Montreal, September 29, 2020

Nitrogen Disc MY2021 – Running change Notice Fork cable guide

Nitrogen Disc fork MY2021 before this running change (a) and after (b).

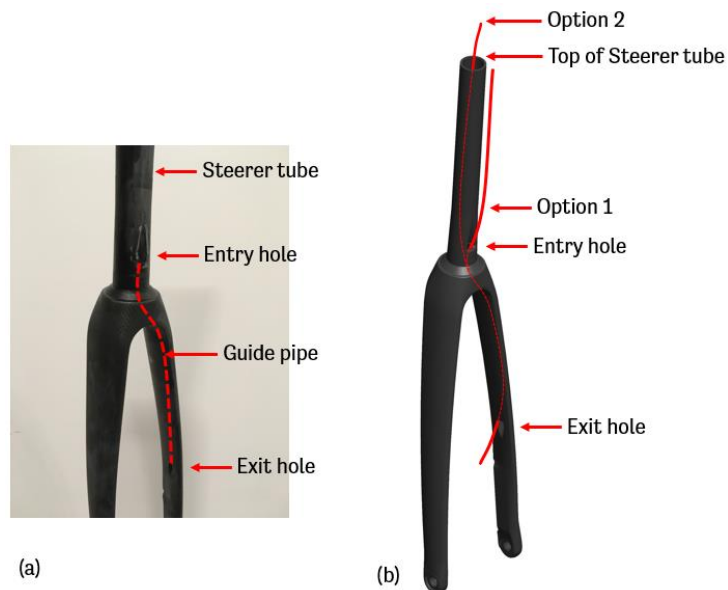
Before this running change:

A guide pipe was used to help routing the brake hoses in the fork, it was placed between the entry hole at the base of the steerer and the exit hole on the left fork leg in this design.

After this running change:

The guide pipe is now removed to enable two (2) options of front brake hose routing:

1. Through the entry hole at the base of the steerer
2. Through the top of the steerer tube*

**This was not possible before this running change*

Argon18 SKU# 81299, FSA ACR headset NO.55R showing the top cover (a); Two ways of routing the cables and hoses with the FSA ACR system (b).

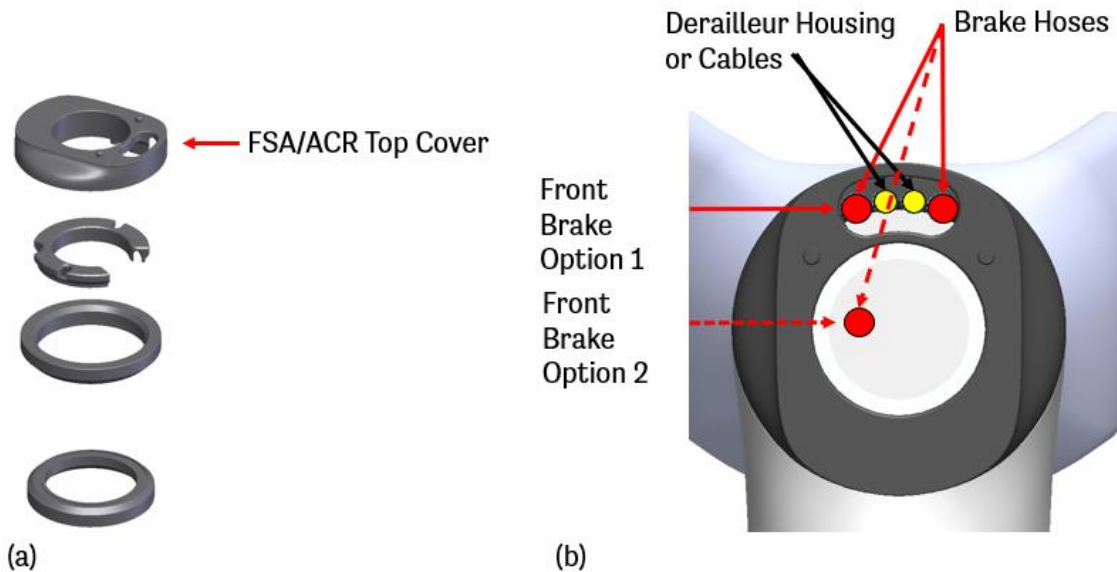
Note that this change does not affect assembly with the **Token S-Box** headset for which the front brake hose is routed through the entry hole.

There are two ways of routing the cables and hoses with the **FSA ACR system**. In both options, shifting cables and rear brake hose are routed through the top cover front hole.

Red line: brake cable/housing / Yellow line: derailleur cable/housing
Cable routing with option 2.

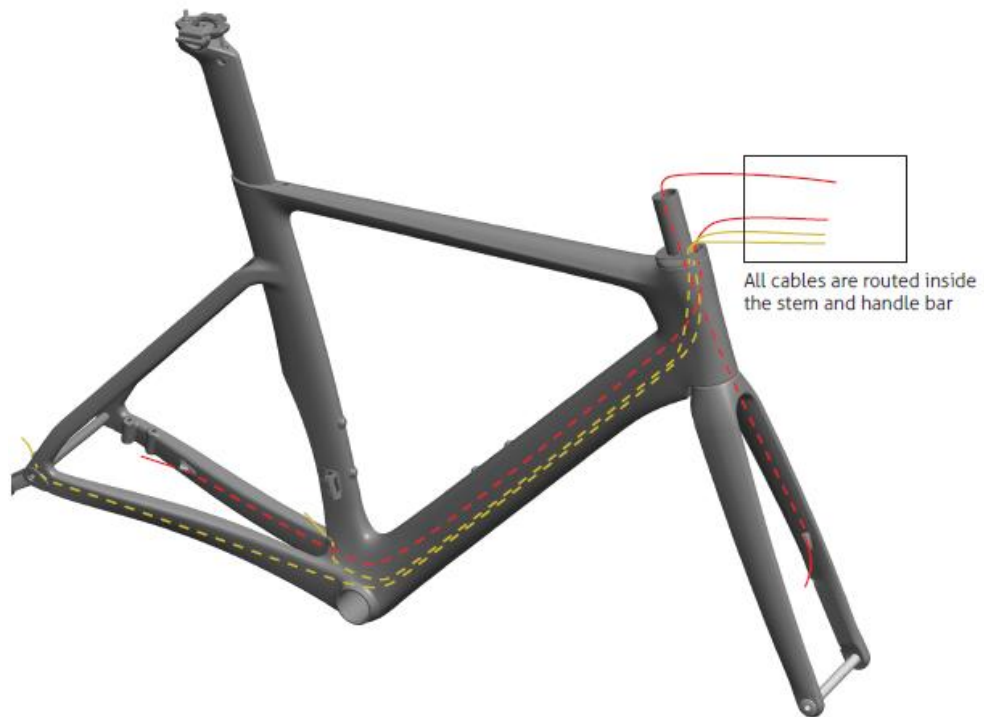
Option 1

The front brake hose is routed through the entry hole and the hole on the top cap. This solution works with forks whether they have a cable guide or not.

Solution 2

The front brake hose is routed through the steerer tube. This solution works only with forks produced after this running change.
